## Department of Transportation

#### MEMORANDUM

**DATE:** April 22, 2022

**SUBJECT:** ZC Case No. 21-18 – 4608-4618 14<sup>th</sup> Street NW

Figure 1 | Site Plan

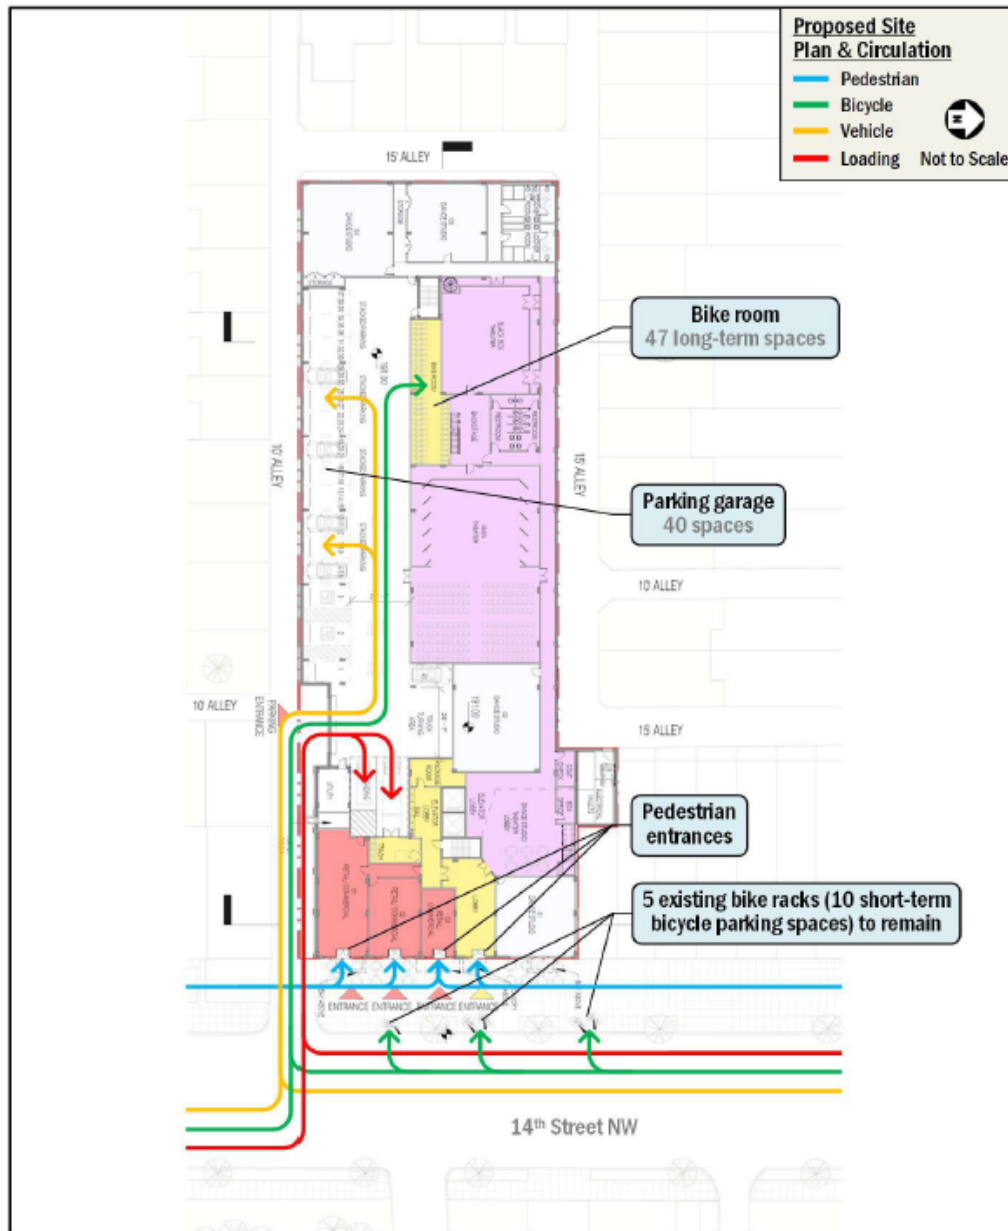
While the preliminary public space plans, shown above in Figure 1, are generally consistent with DDOT standards, there are several considerations that need to be reviewed in greater detail during the public space permitting process:

- An occupancy permit will be required for any portion of the outdoor café in public space along the 14<sup>th</sup> Street NW frontage;
- Building projections on 14<sup>th</sup> Street NW should not project more than 4-feet into public space;
- The final location of the expanded 19-dock Capital Bikeshare station;
- The design and installation of the safety improvements at the intersection of 14<sup>th</sup> Street NW & Crittenden Street NW;
- The addition, and final location, of a street tree on the 14<sup>th</sup> Street NW frontage; and
- The final location of the five (5) short-term bicycle racks to accommodate 10 short-term bicycle parking spaces.

### **Figure 4 | Existing Pedestrian Network**

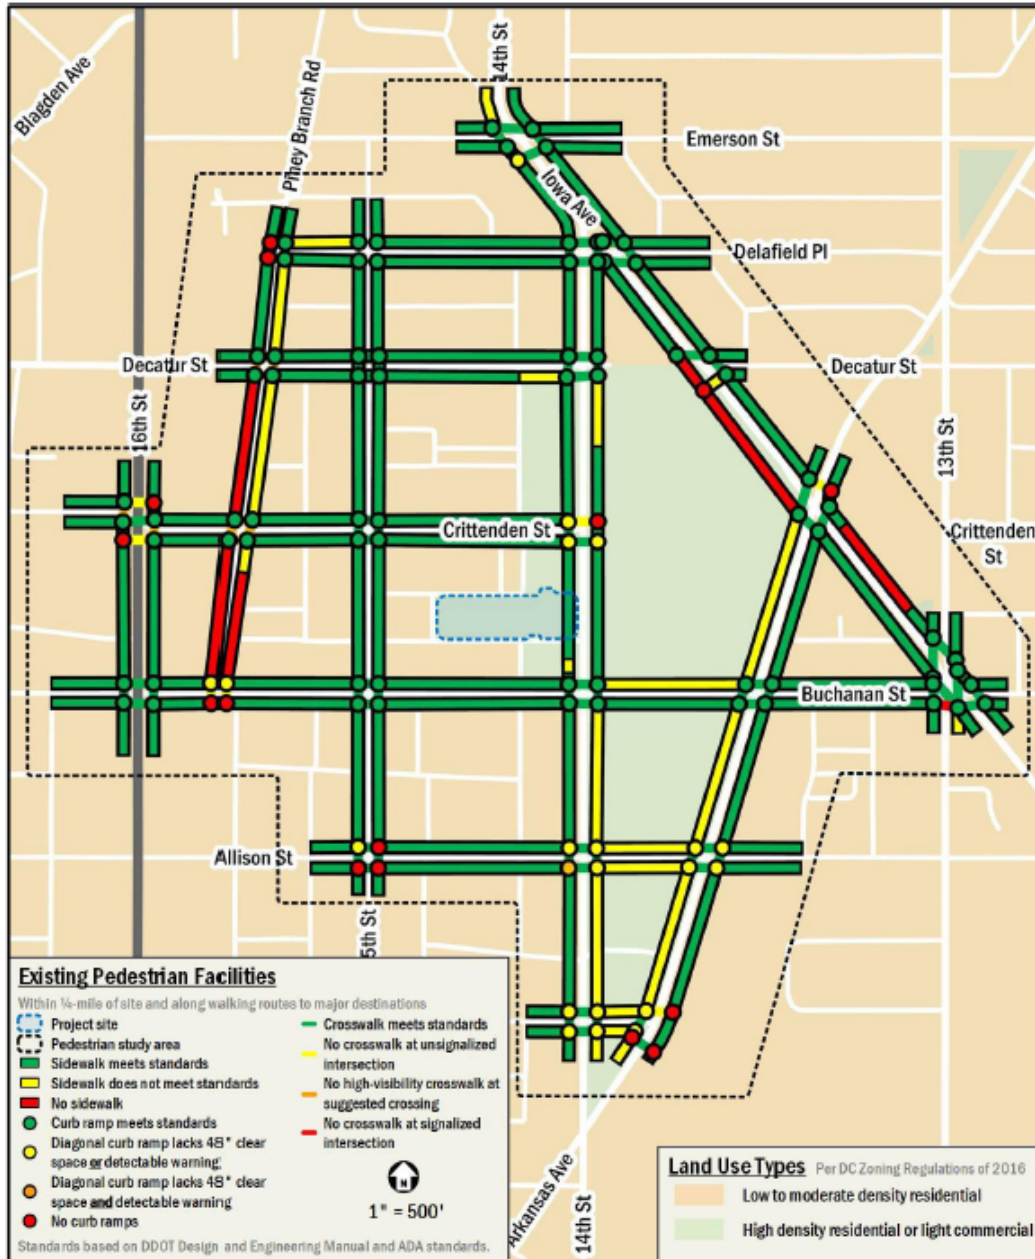
The Applicant's inventory of existing pedestrian infrastructure, as shown in Figure 7 below, demonstrates that most sidewalks in the immediate vicinity of the site are currently constructed with appropriate widths and include accessible curb ramps, with the exception of the intersection of 14<sup>th</sup> Street NW and Crittenden Street NW.

The Applicant should bring the intersection of Crittenden Street NW and 14<sup>th</sup> Street NW up to standard and add additional pedestrian countermeasures, as that intersection is an uncontrolled pedestrian crossing that will have additional use due to this development. The following upgrades should be made to this intersection, subject to DDOT approval:

- ADA ramps upgraded on all four legs of the intersection;
- New high-visibility crosswalk on the north leg of the intersection;
- Assessment of condition and restriping (if needed) of existing crossings; and

- Curb extensions on all four legs of the intersection, including removing parking from the middle of the intersection.

In conjunction with a robust TDM program, DDOT finds these intersection improvements to be acceptable and appropriate mitigation. DDOT notes that the final design of the curb extensions, curb ramps, and crosswalks will occur during public space permitting.
